Access Compliance Report

Public Rights-of-Way

(Curb Ramps)

Intersection ID: 14396	Main Street: BRIAR_CREEK_RD	Cross Street: COMMONWEALTH_AV	Location: E
ADA ID: D25A5FFD598F	Ramp Type: PerpDiag	Initial Pass/Fail: Fail	Overall Compliance: No
Severity Score: 22.5			
Codes/Mitigation Info/Possible Solution		Field Measurements/Component Compliance

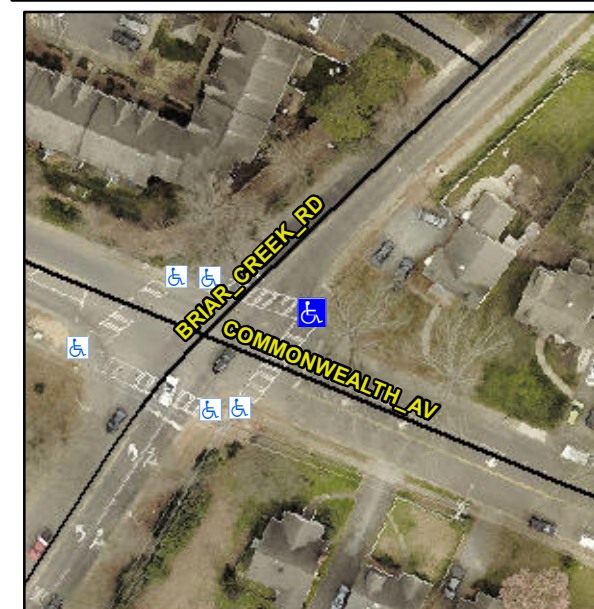
Not Found, R304.5.1, R304.2.2, R304.5.3

Compliance	Description	Data	Compliance	Description	Data
N/A	Ramp Length (in)	60.0	No	Ramp Slope (%)	9.4
No	Ramp Width (in)	39.5	No	Ramp XSlope (%)	4.8
N/A	Flare Type LT	N/A	N/A	Flare Type RT	N/A
N/A	Flare Slope LT (%)	N/A	N/A	Flare Slope RT (%)	N/A
N/A	Flare Traversable LT?	N/A	N/A	Flare Traversable RT?	N/A
N/A	Landing Length (in)	N/A	N/A	DWS Provided?	N/A
N/A	Landing Width (in)	N/A	N/A	DWS Contrast?	N/A
N/A	Landing Slope (%)	N/A	N/A	DWS Length (in)	N/A
N/A	Landing X Slope (%)	N/A	N/A	DWS Full Width?	N/A
N/A	Landing Curb? (Y/N)	N/A	N/A	DWS Offset (in)	N/A
N/A	Shared Landing?	N/A			
N/A	Gutter Ponding?	N/A	N/A	Gutter Slope (%)	N/A
N/A	Gutter Lip Ht (in)	N/A	N/A	Gutter X Slope (%)	N/A
N/A	Painted X Walk1?	Yes	N/A	Painted X Walk2?	Yes
	X Walk 1 Direction	To NW		X Walk 2 Direction	To SW
N/A	X Walk 1 Width (in)	111.0	N/A	X Walk 2 Width (in)	111.0
	X Walk 1 Slope (%)	0.2		X Walk 2 Slope (%)	3.6
	X Walk 1 X Slope (%)	4.5		X Walk 2 X Slope (%)	1.0

N/A	Ramp inside XWalk1?	Yes	N/A	Ramp inside XWalk2?	Yes
	Road Slope (%)	4.2	N/A	Clear Space?	N/A
	Road X Slope (%)	1.2	N/A	Clear Space to XWalk (in)	N/A
N/A	Any Obstructions?	N/A	N/A	Storm Grate/Utility Hazard?	N/A
	Obstruction Type			Storm Grate/Utility Type	
		N/A			N/A
		Yes		Surface Condition? (G/P)	Good

Remove & Replace Curb Ramp With Two New Directional Ramps or Equivalent.
